BID # 26-006

PHASE 2 SHADE STRUCTURES – 5 SITES
VICTOR ELEMENTARY SCHOOL DISTRICT
VICTORVILLE, CA

July 6th, 2026

ADDENDUM – 01

SHADE CANOPY - SITE PLAN

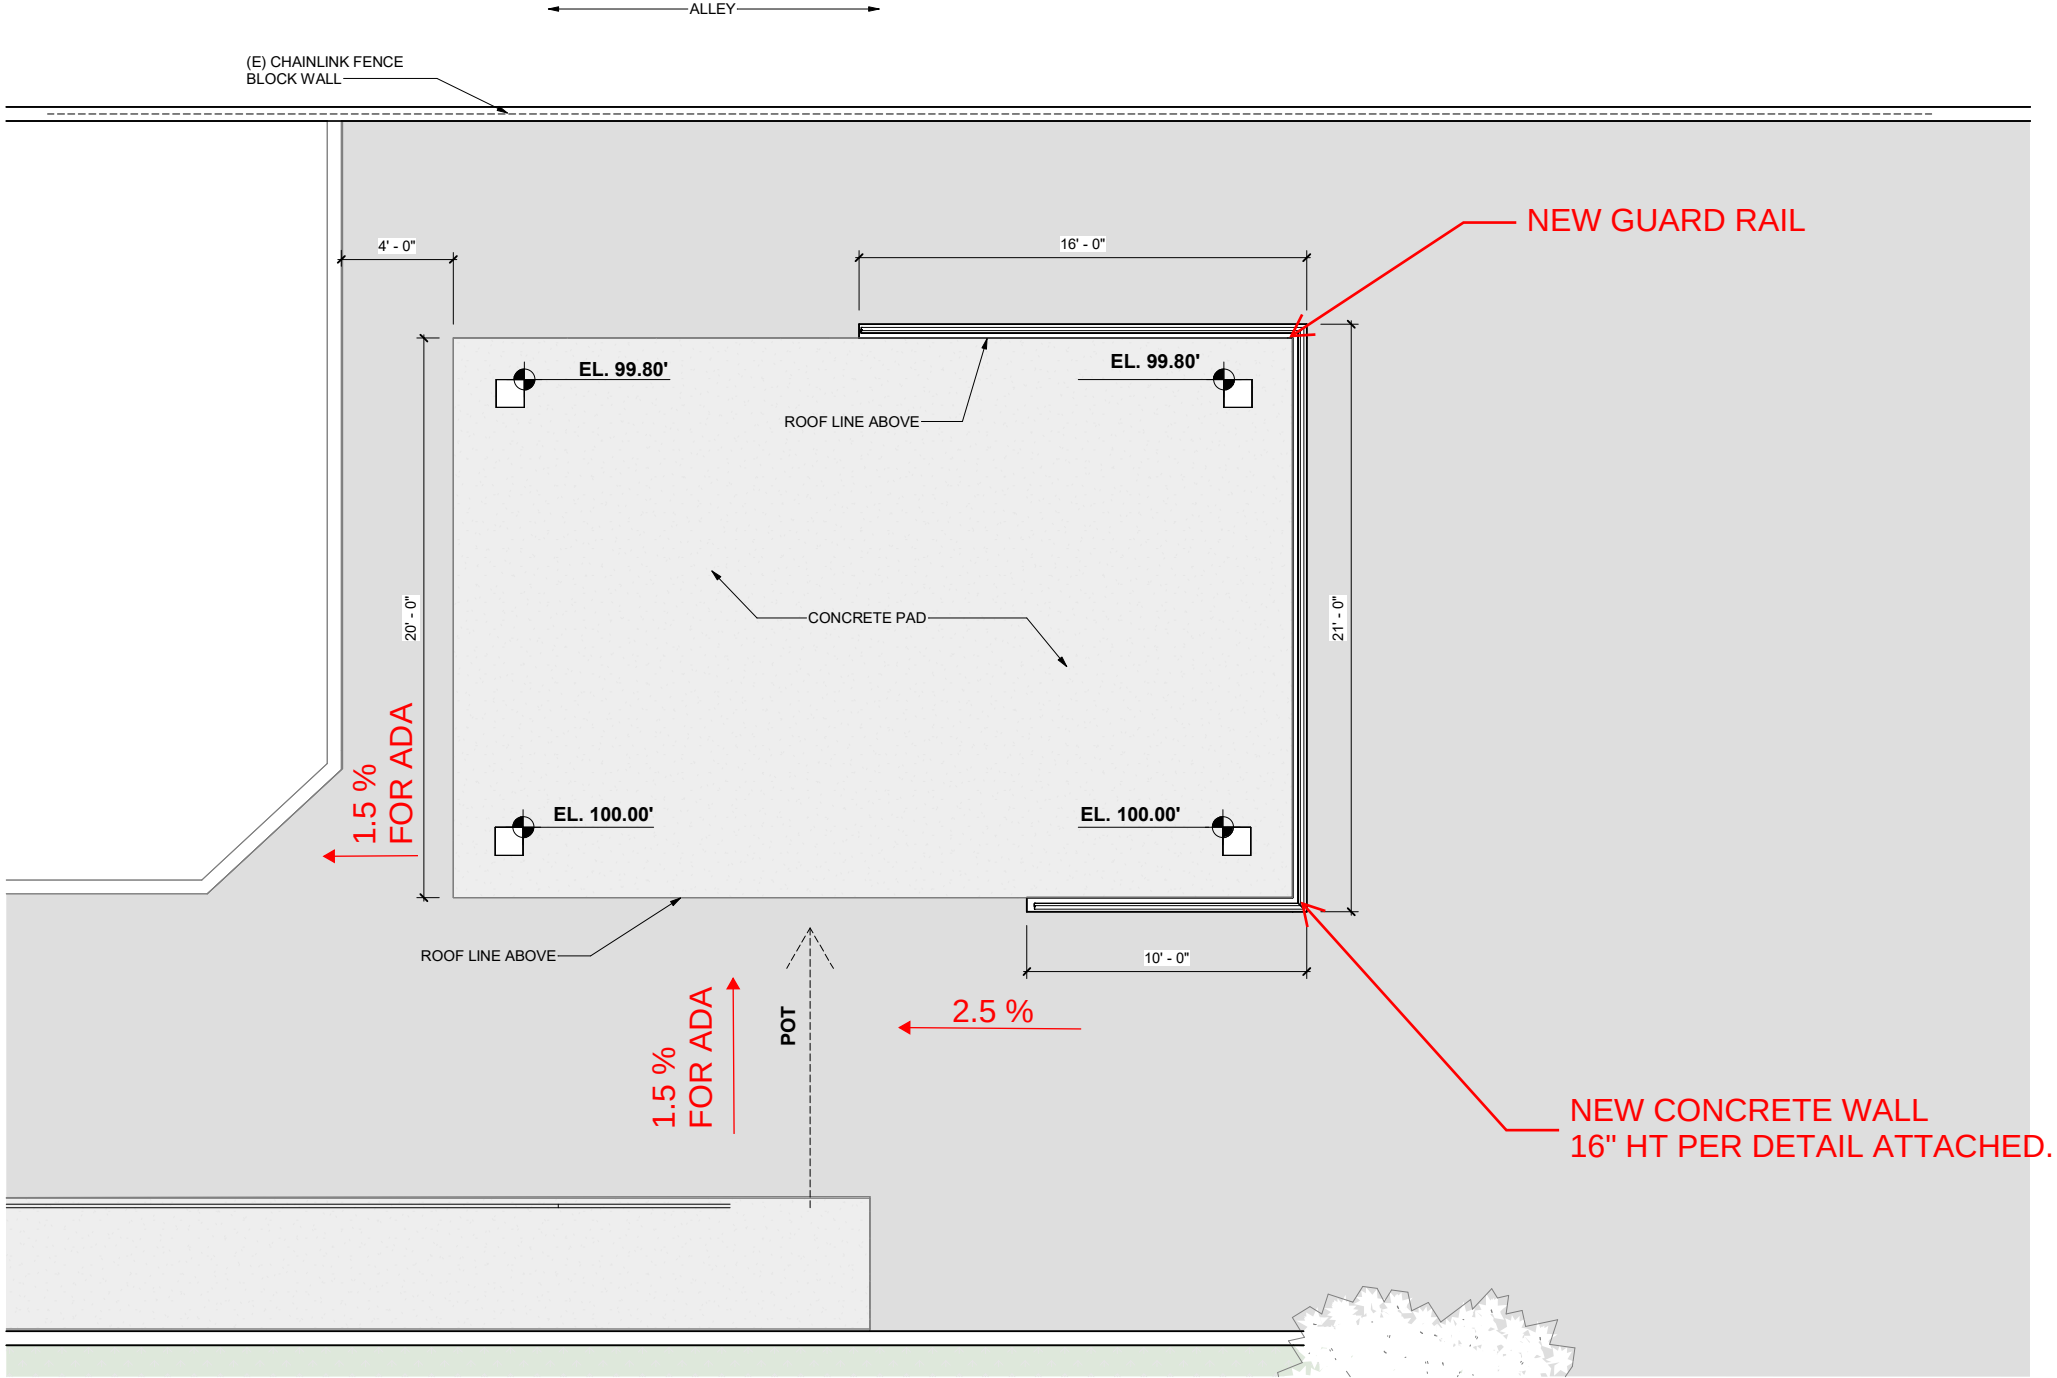
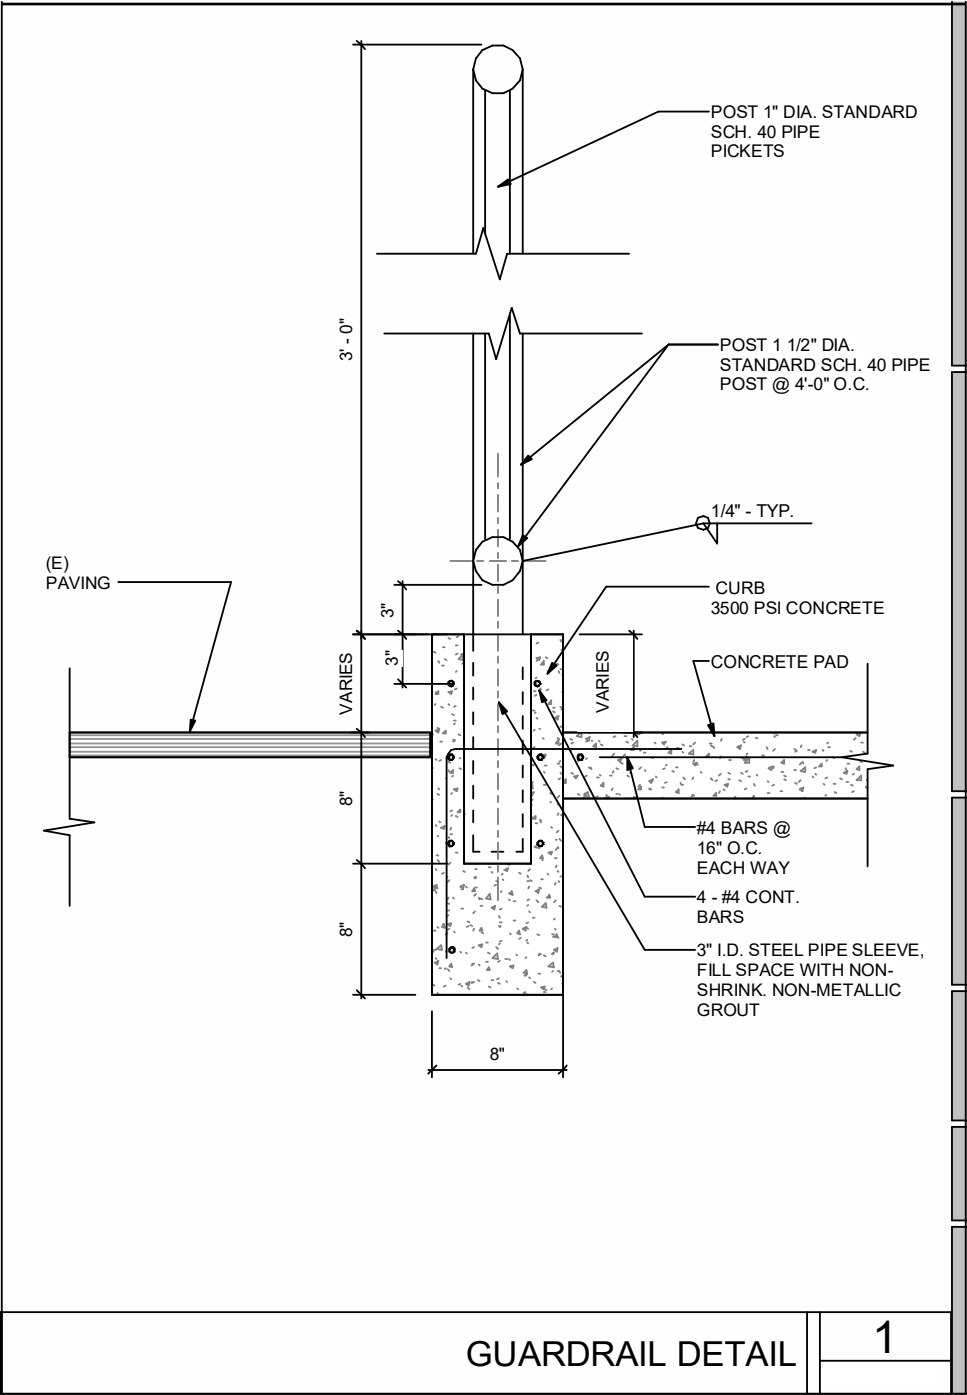
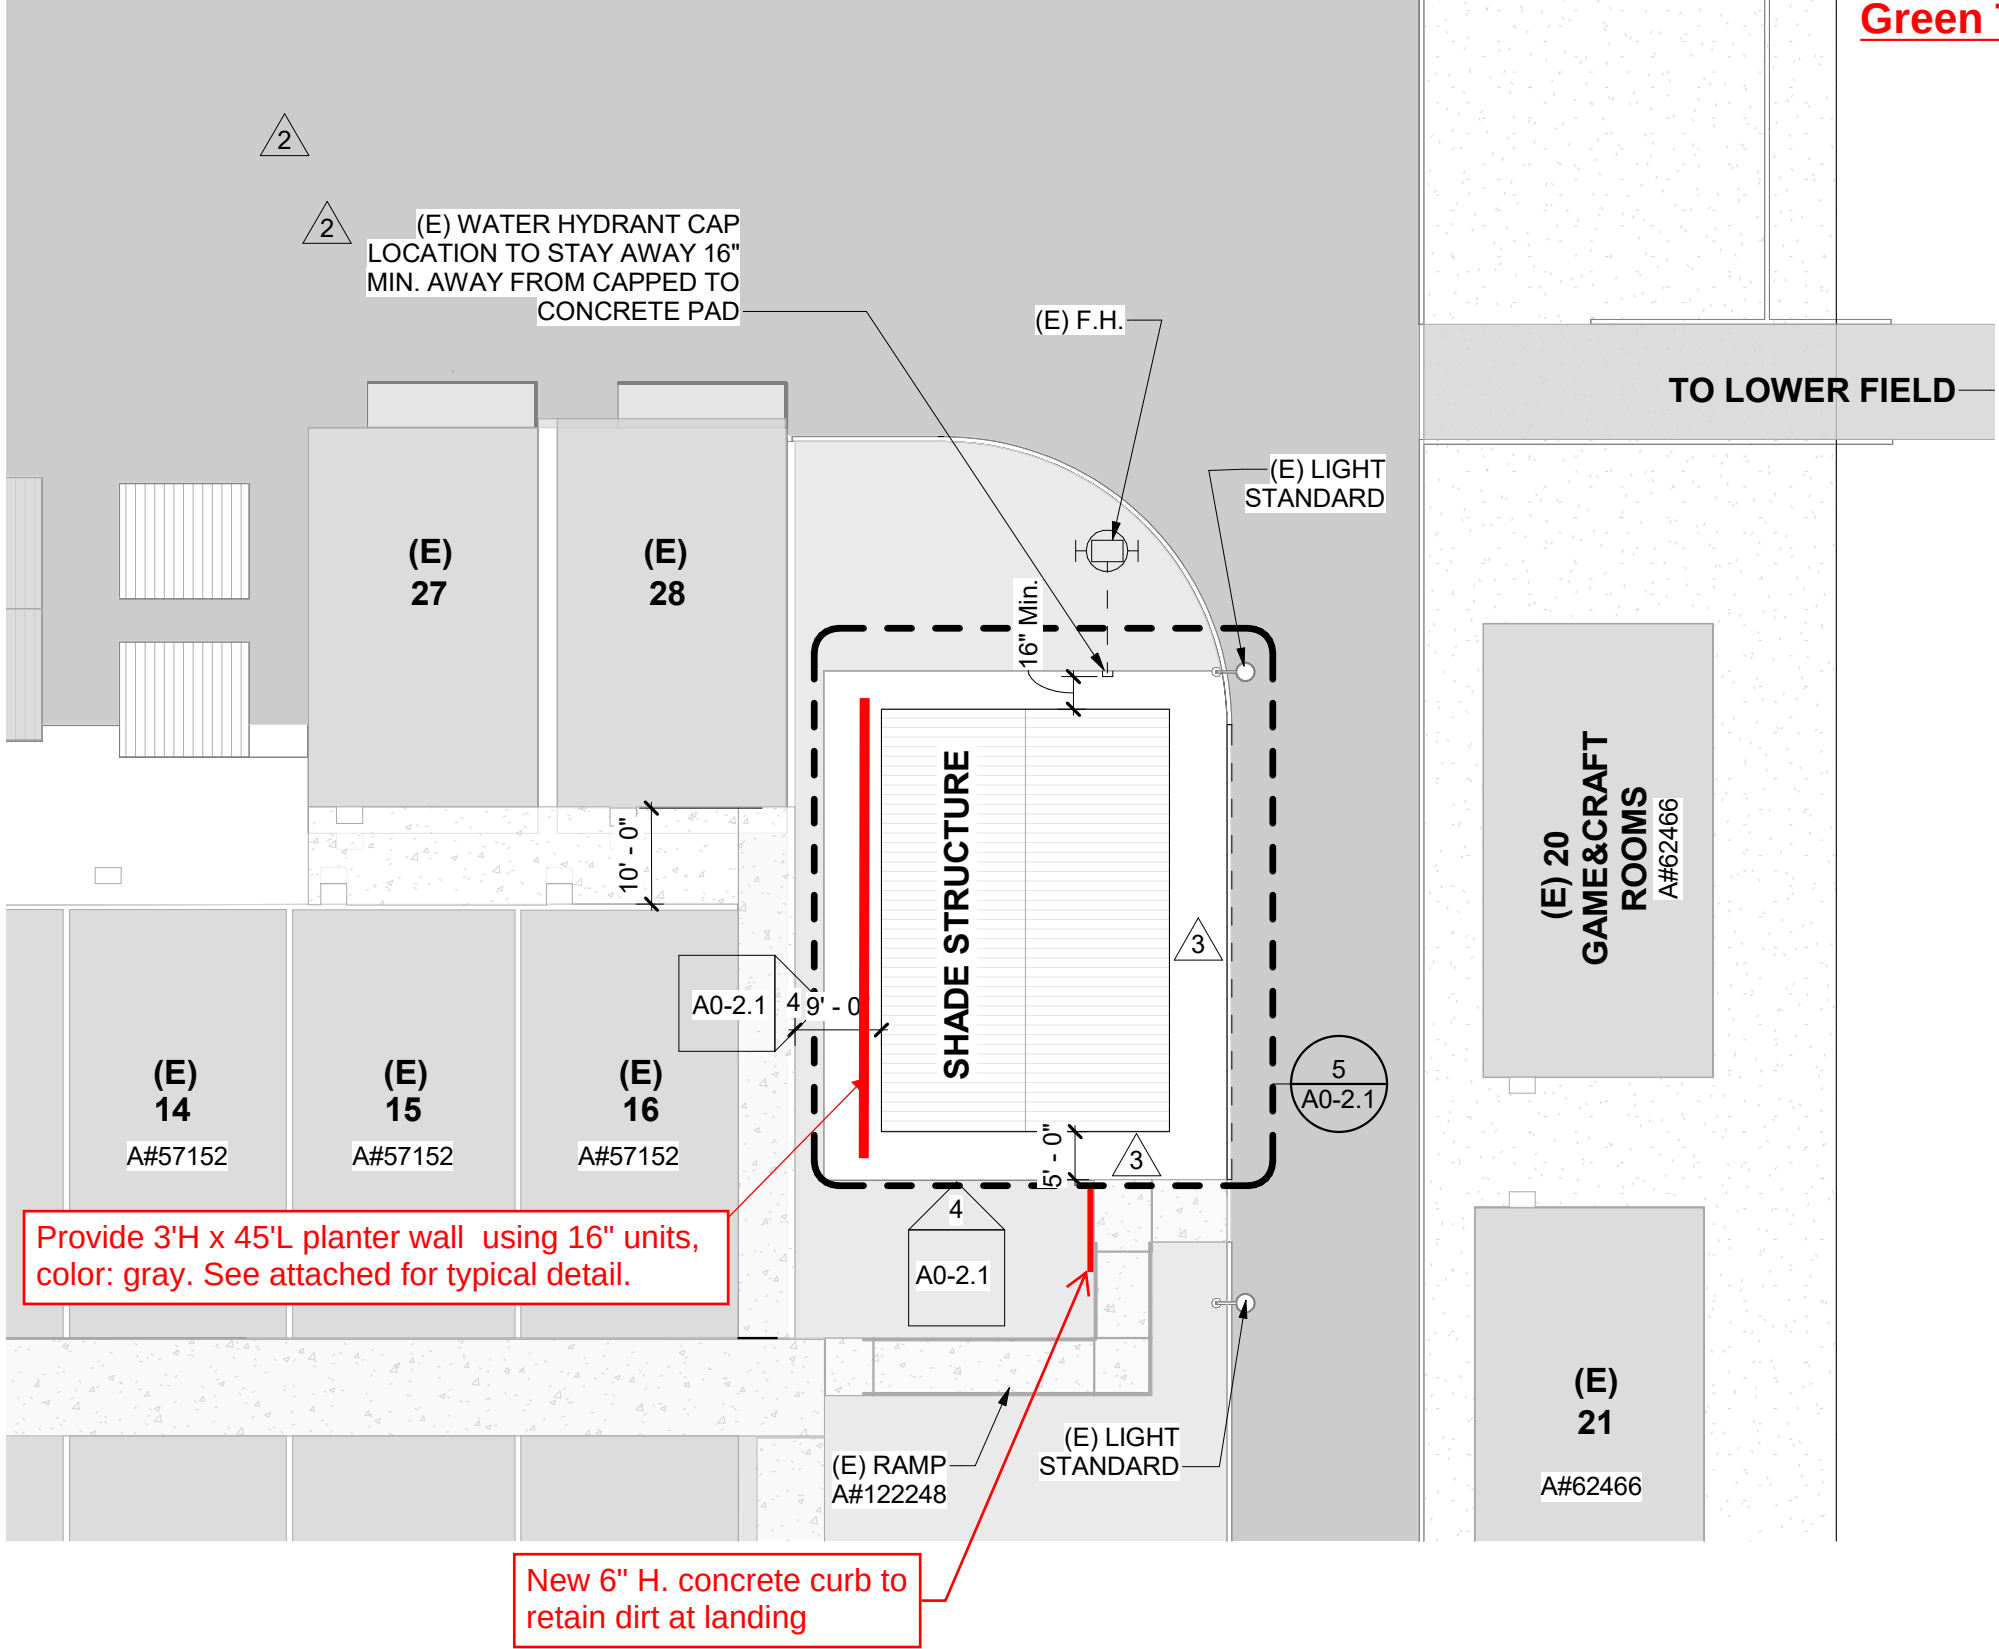
Demolish and replace existing landing at bottom of ramp to match existing for accessibility compliance with 6 inch concrete curb on southern edge to account for grade difference. Landing to be a minimum of 6' x 6' and concrete with rebar spaced out even within the space.
